State of Alaska
Department of Fish and Game
Sportfish Division

Nomination Form
Anadromous Waters Catalog

Anadromous Waters Catalog Number of Water Body 114-34-10200

Name of Water Body Halibut Creek

Figure 5.-114-34-10200 route correction (upstream) map.

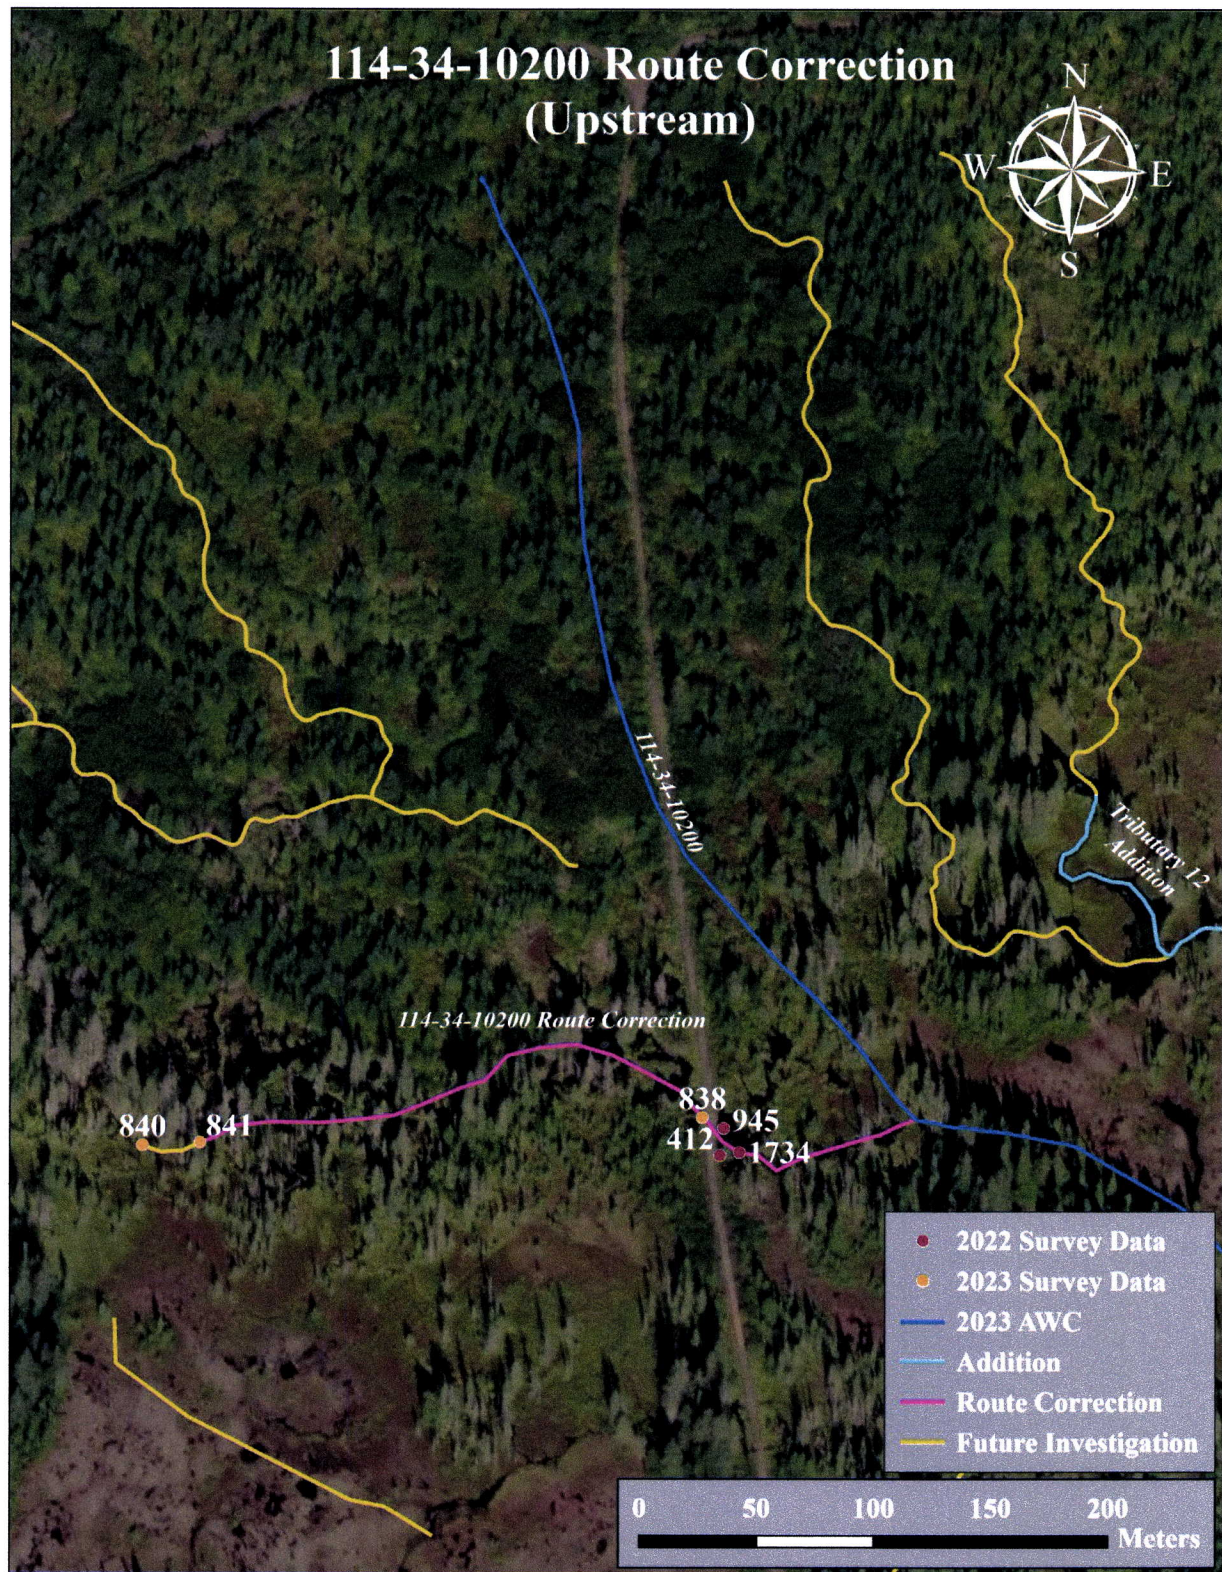
Recommendations: Correct Stream No. 114-34-10200 in the anadromous waters catalog to reflect the field verified stream path (Figure 5). Also extend the downstream reach of stream into the intertidal (Figure 6).

- UPDATE/RELOCATE mouth point position of existing AWC Stream #114-34-10200 "Halibut Creek" to better approximate the location of Mean-Low-Water (MLLW).
- UPDATE/ADJUST upper hydrography segment of existing AWC Stream #114-34-10200 "Halibut Creek".
- Please update using most recent .GDB with line, point, lake, polygon and barrier features located in O:\DSFIR5\AWC\Draft2025\GIS\DATA\AWC_2025update_WORKINGv1_day-month-yr.gdb
